EMISSIONS RECALL

CRF450RL ECU Inspection

Honda is launching an **EMISSIONS RECALL** on **CERTAIN 2022 CRF450RL** motorcycles to inspect the Engine Control Unit (ECU). The affected units may have had an incorrect ECU installed at the factory. A motorcycle with an incorrect ECU may exhibit drivability issues and is not within emissions certification compliance.

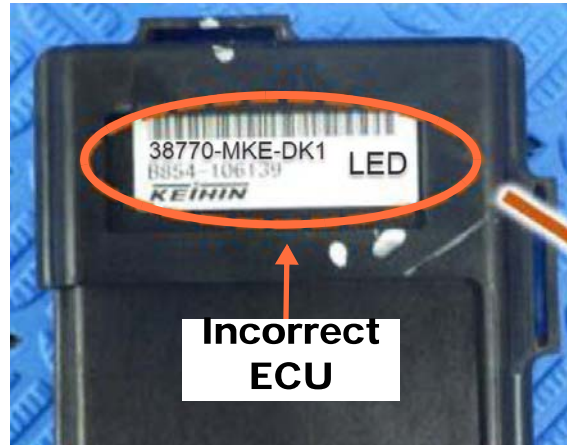
6. Confirm the ECU is correct.

- **Incorrect P/N:** 38770-MKE-DK1 (LED)

- **Correct P/N:** 38770-MKE-AK1 (LAC)

Note: If the ECU has the incorrect part number, take a photo of the part number and call *TechLine* to have the correct ECU shipped to your dealership.
